# Lloyd's Register of Shipping.

Ship's Name **"WAINUI"**

Memorandum of alterations reported since ship was surveyed for assignment of Load Lines

in PORT of DUNEDIN, N.Z. 12th February 1949.

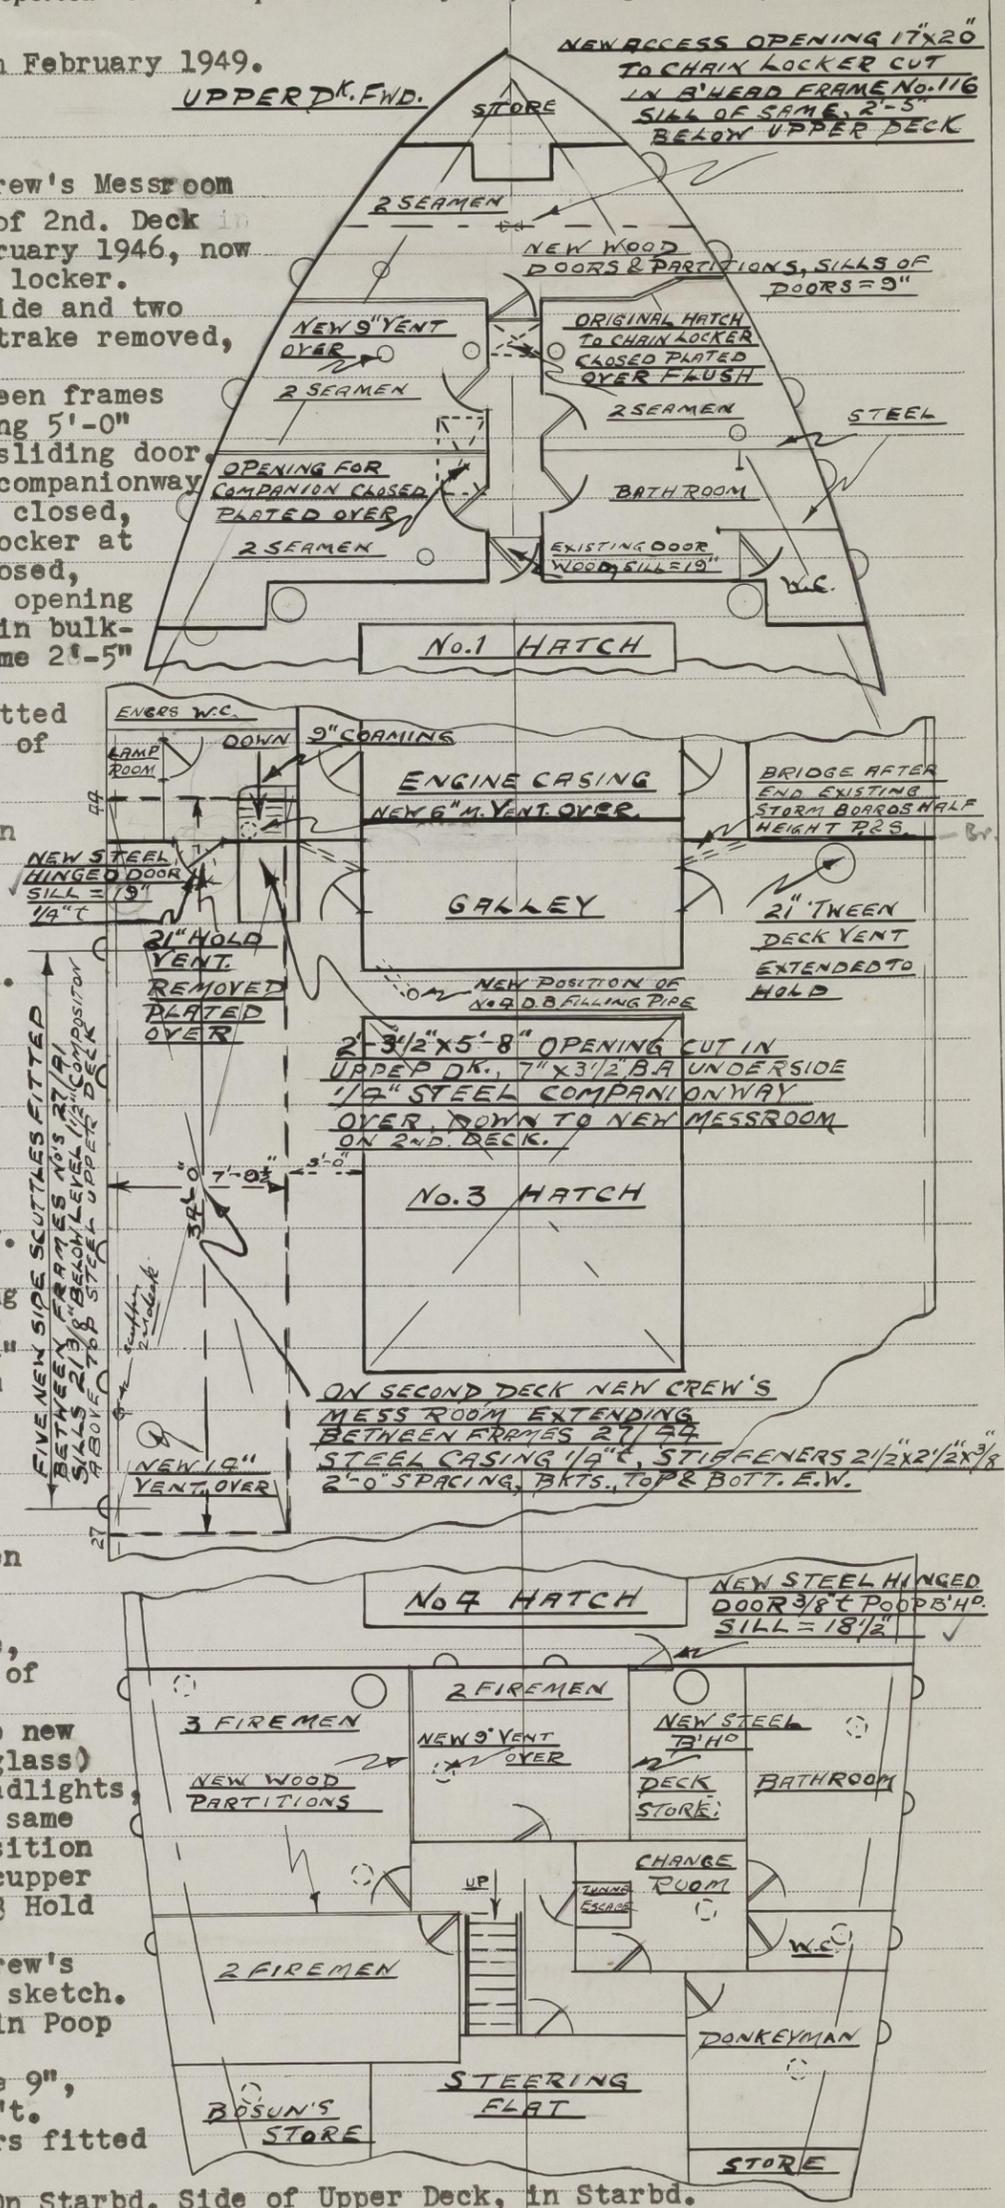
Accommodation for seamen fitted as per adjacent sketch. Sills of doors in passageway = 9".

**Poop Space:-** Refitted for Crew's accommodation as per adjacent sketch. New steel hinged door fitted in Poop bulkhead, 3/8" t, Sill = 18 1/2".
